**RE: Unser & Vista Oriente Shell Building, Lot 1-B-3, Ladera Industrial Center,
Unser Boulevard
Grading and Drainage Plan
Engineer's Stamp Date 5-19-2015 (File: H10-D006A5)**

DRAINAGE AND TRANSPORTATION INFORMATION SHEET

RE: Unser & Vista Oriente Shell Building, Lot 1-B-3, Ladera Industrial Center, Unser Blvd. (H10-D006A5)

**RE: Unser & Vista Oriente Shell Building, Lot 1-B-3, Ladera Industrial Center,
Unser Boulevard
Grading and Drainage Plan
Engineer's Stamp Date 5-19-2015 (File: H10-D006A5)**

SHEET NO:
CG-101

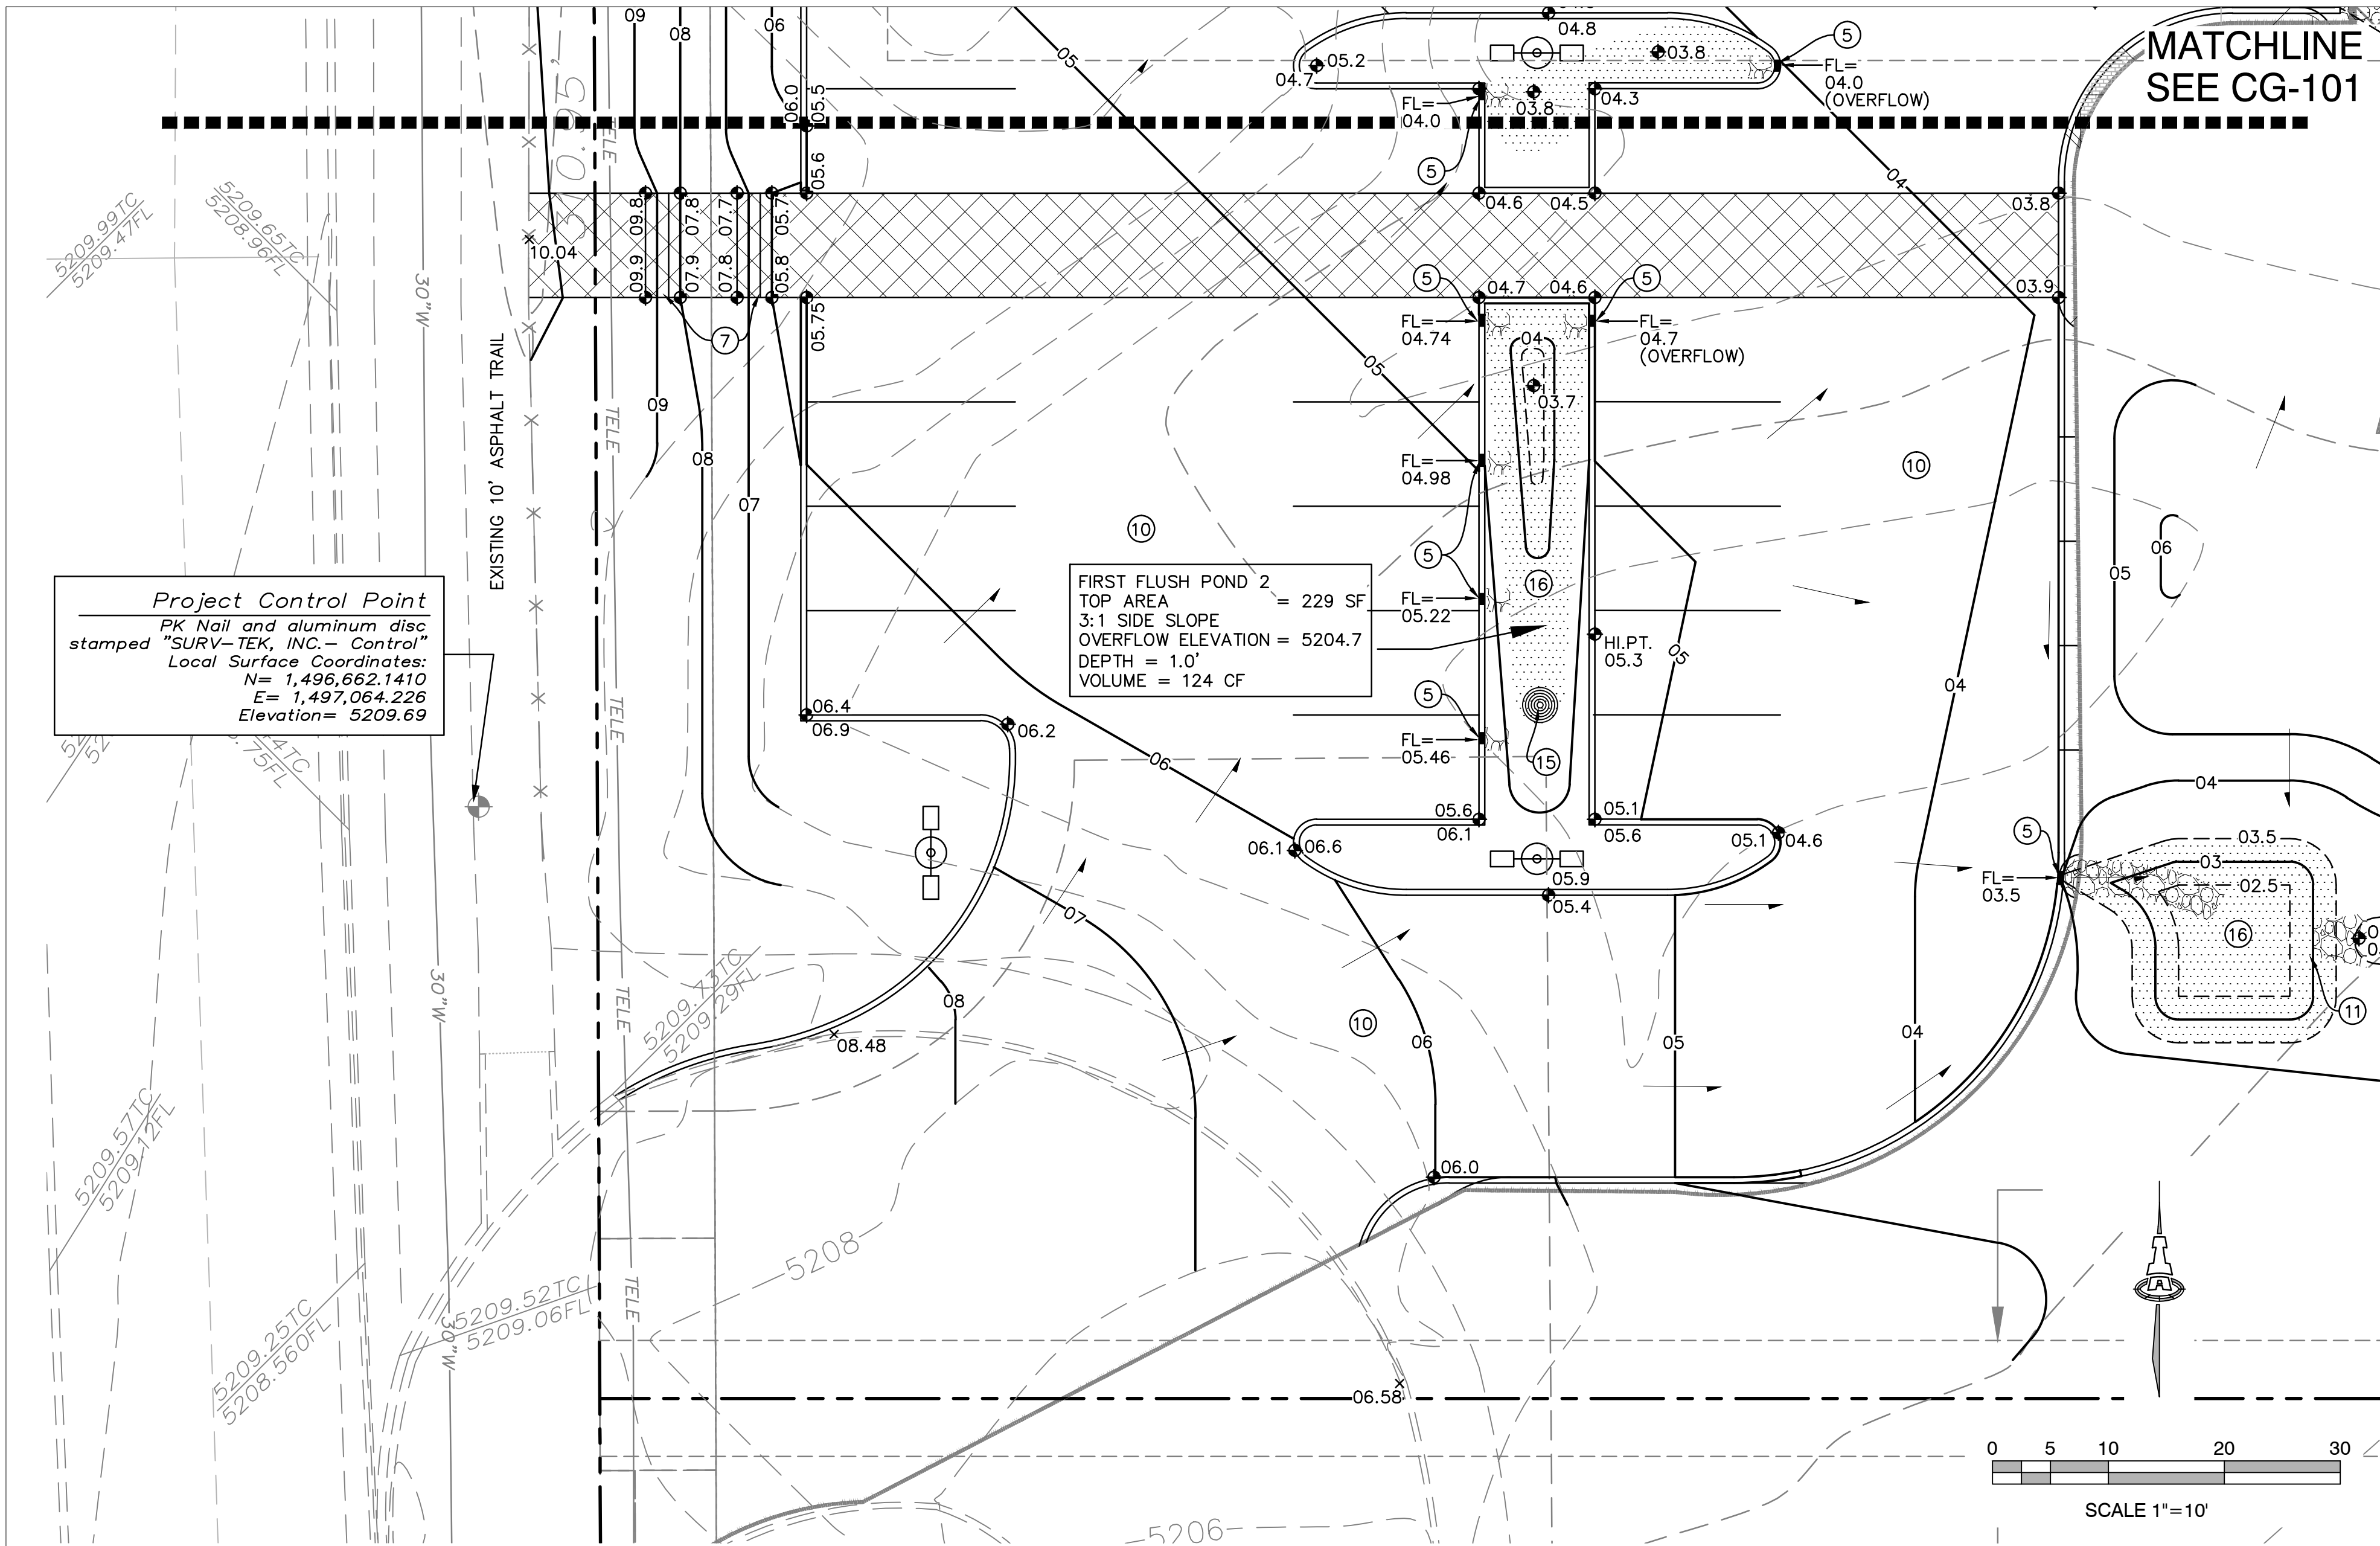
- b. Regarding cross-lot drainage: per our Drainage Concept on Sheet CG-101: EXISTING MUTUAL CROSS LOT DRAINAGE EASEMENT FOR THE BENEFIT OF LOTS 1-B-1 THRU 1-B-4 GRANTED BY PLAT FILED JANUARY 26, 2012. SAID EASEMENT SHALL RUN OVER, UNDER AND ACROSS THE COMMON AREAS (MEANING THOSE AREAS OF LOT NOT OCCUPIED BY A BUILDING FROM TIME TO TIME AND AT ANY APPLICABLE TIME). MAINTENANCE OF SAID EASEMENT SHALL BE THE RESPONSIBILITY OF THE RESPECTIVE LOT OWNERS AS TO THE PORTION CONTAINED WITHIN THEIR RESPECTIVE LOT.

- 1) Provide excerpts from the Ladera Industrial Center Site Development Plan showing that the site adjacent to the east is accepting on-site flow. Since the storm flow is increased from existing conditions, a cross-lot access agreement may be needed unless one is already in place to accept the proposed 100-year flow.
- 2) A couple of the new spot elevations were cut off on the right side of the plan view on Sheet CG-102.
- 3) For Basin 3 on Sheet CG-501, the labeling of the basin area on the plan view needs to match the basin area in the calculations. Also, label lot line for Lot 1-B-3.
- 4) Show roof drains.

- BUILDING ROOF DISCHARGE LOCATION. EXTEND DRAIN PIPE THROUGH WALK TO RELEASE DIRECTLY TO FIRST FLUSH POND #1. SEE ARCHITECTURAL FOR ADDITIONAL INFORMATION.
